In relation to the response from Central Coast Council and request for additional information relating to the Waste Management Plan for the development.

STANBURY TRAFFIC PLANNING
60-64 SHOWGROUND ROAD, GOSFORD
CAR PARK COMPLIANCE REVIEW
SWEPT PATH ASSESSMENT
GROUND

SCALE 0 2.5 5.0 1:250@A3
DRAWING NO. 23-084-01-V10
DATE 15 May 2024

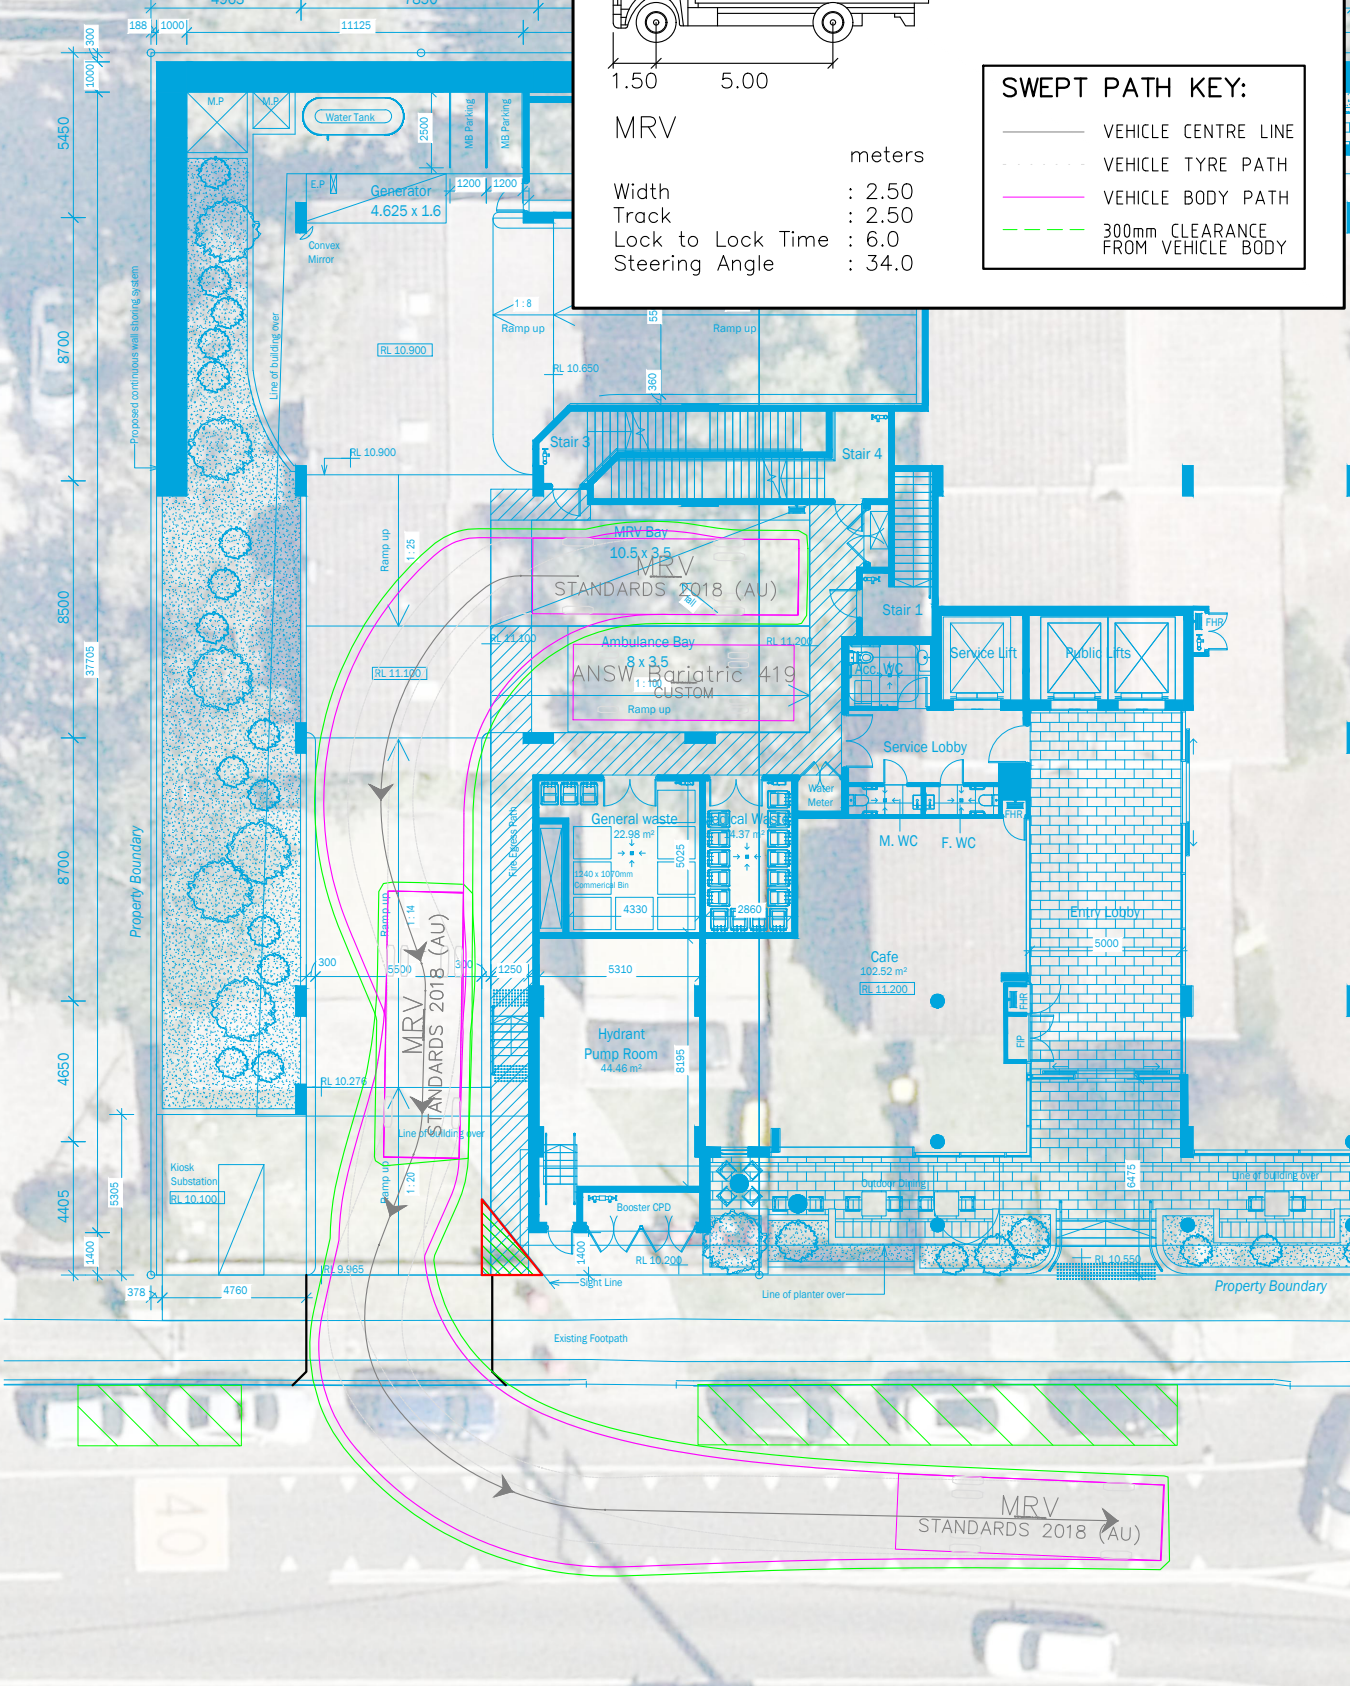
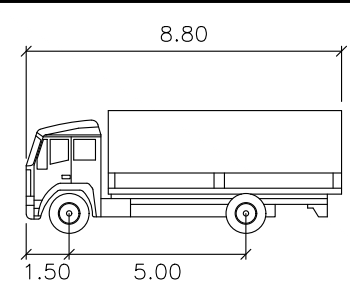
- Swept path assessment provided with the modification application illustrates MRV and ambulance servicing can occur independently of one another. These swept paths are annexed to this letter.
